SOLICITATION AMENDMENT
MODIFICATION DE L'INVITATION

Title - Sujet 50 Bed Living Unit, Westmorland Ins	
Solicitation No. - N° de l'invitation EC016-130878/A	Amendment No. - N° modif. 015
Client Reference No. - N° de référence du client R.043929.001	Date 2012-09-13
GETS Reference No. - N° de référence de SEAG PW-\$PWB-020-3101	
File No. - N° de dossier PWB-2-35024 (020)	CCC No./N° CCC - FMS No./N° VME
Solicitation Closes - L'invitation prend fin at - à 02:00 PM on - le 2012-09-19	Time Zone Fuseau horaire Atlantic Daylight Saving Time ADT
F.O.B. - F.A.B. Plant-Usine: <input type="checkbox"/> Destination: <input type="checkbox"/> Other-Autre: <input type="checkbox"/>	
Address Enquiries to: - Adresser toutes questions à: Donovan, Janine PWB	Buyer Id - Id de l'acheteur pwb020
Telephone No. - N° de téléphone (506) 636-5347 ()	FAX No. - N° de FAX (506) 636-4376
Destination - of Goods, Services, and Construction: Destination - des biens, services et construction:

Modification numéro 15

.6 Reference Drawing MC-403, Controls Details

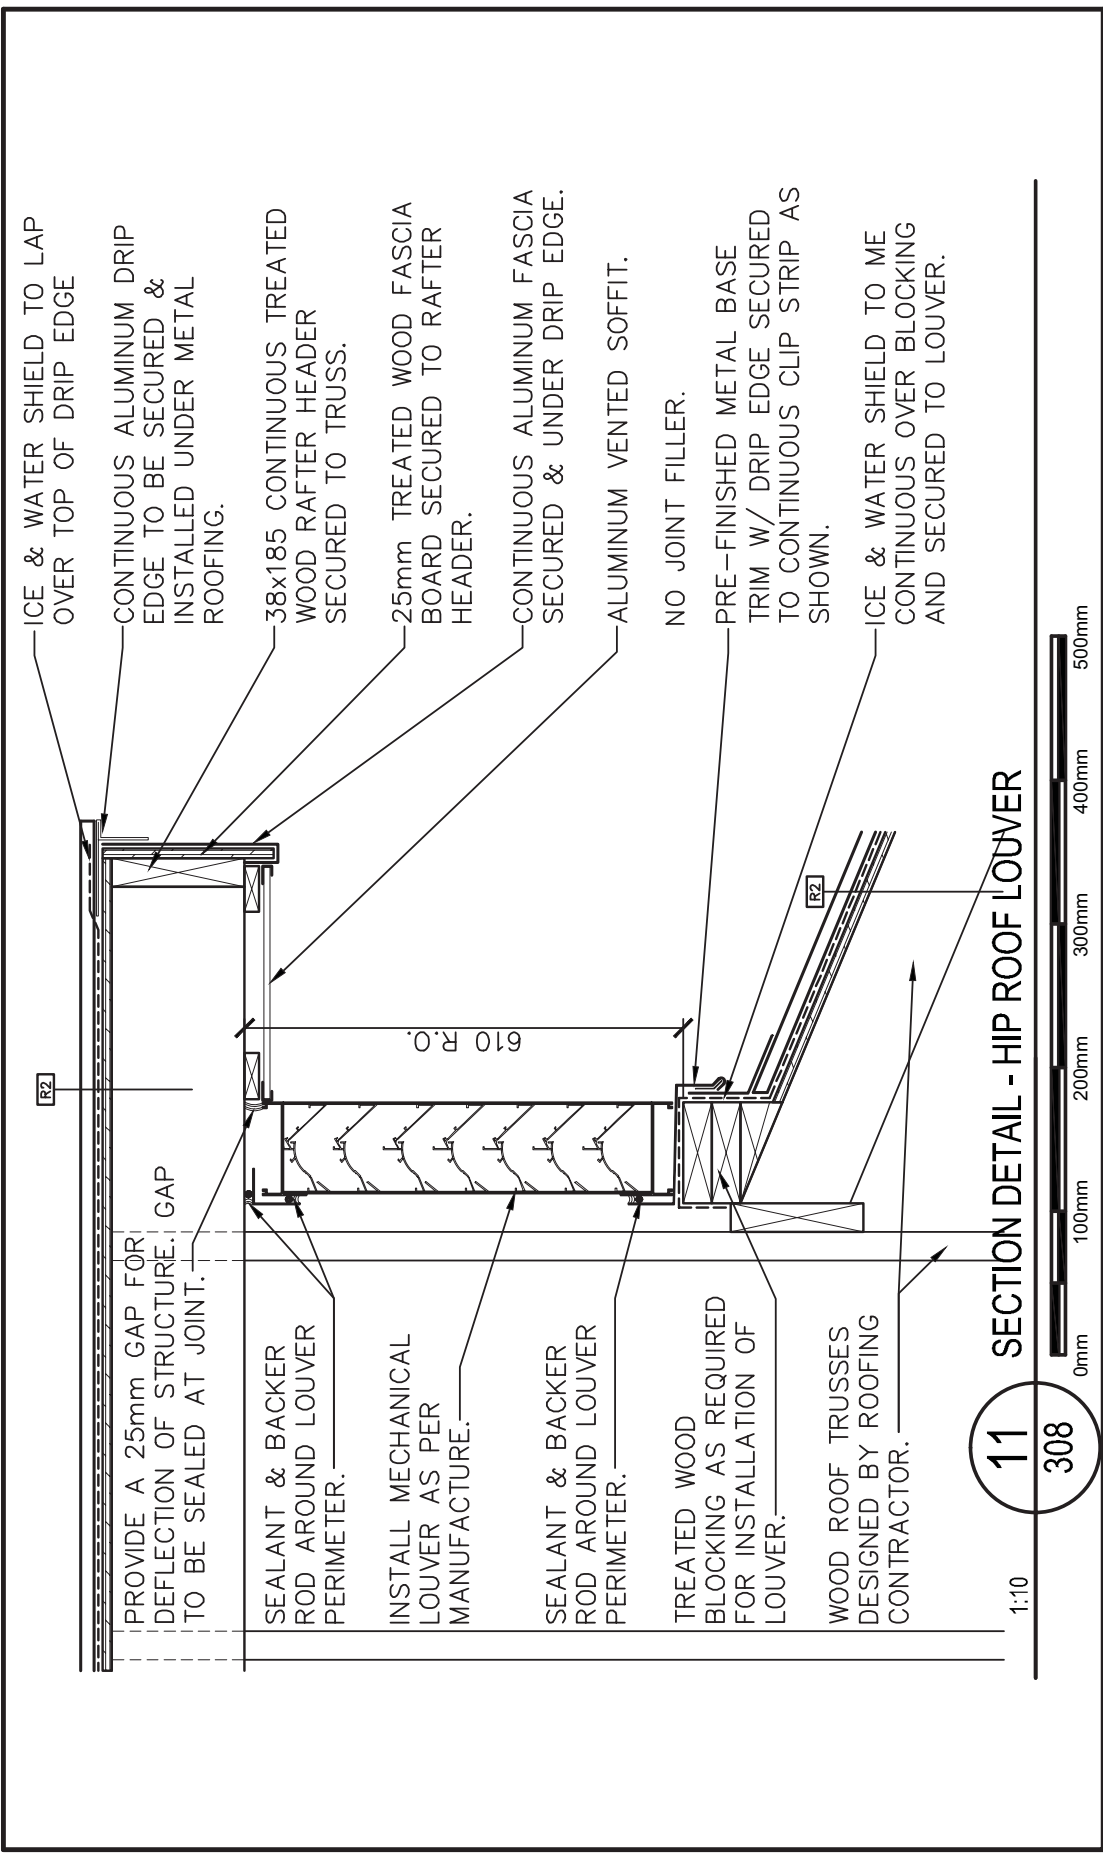
- .1 Provide control points for Variable Air Volume Terminal Units and reheat coils as per attached sketch CSK-001.

.7 Reference Drawing SP-902, Ground Floor Plan Sprinkler System

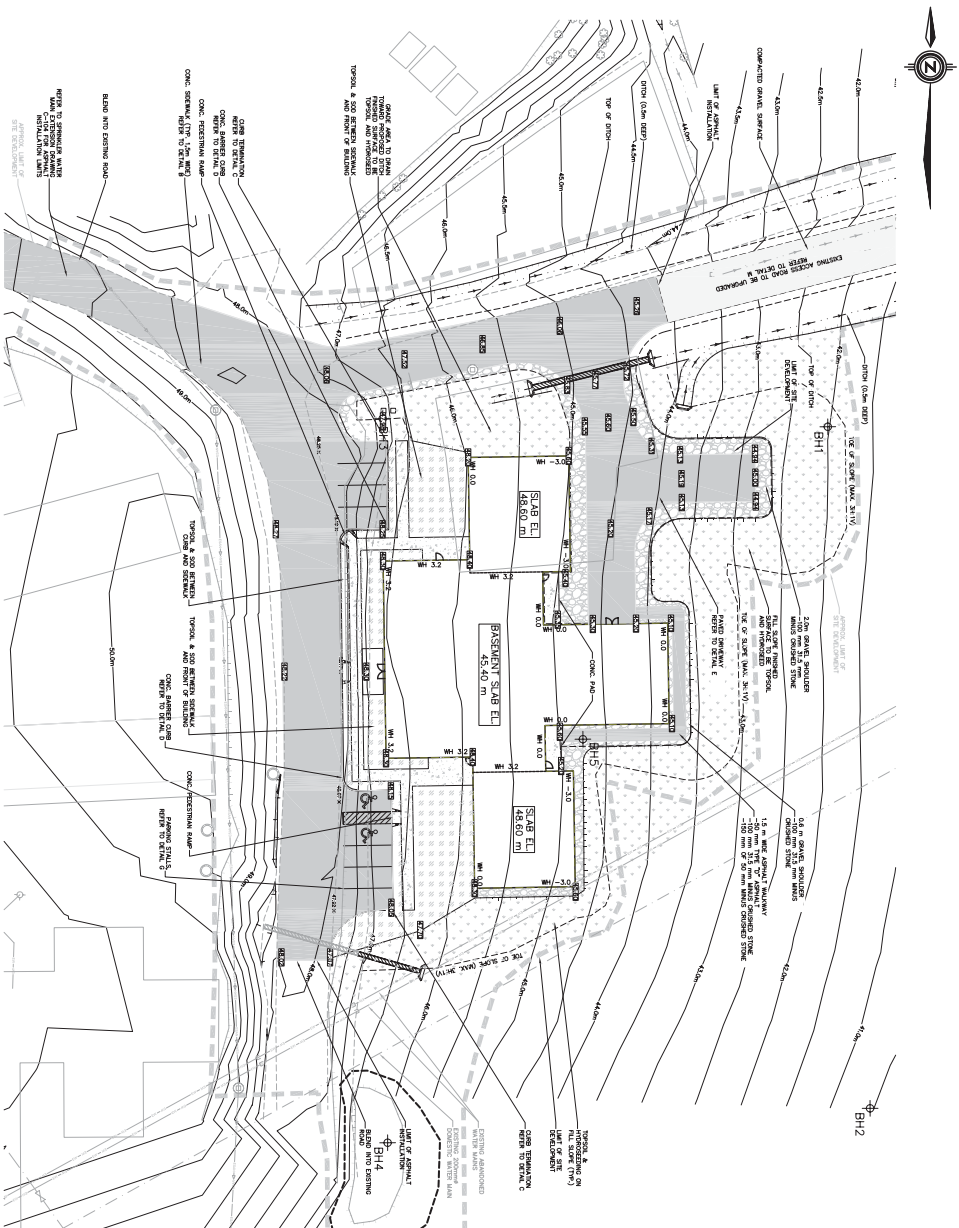
- .1 Provide the following side wall protective spray head for residential range hoods:
Protectospray Nozzle (7.5 mm orifice, 163C temperature rating, 160 angle of discharge) Head is based on a Tyco (formerly Gem/Grinnell) Model EA-1.
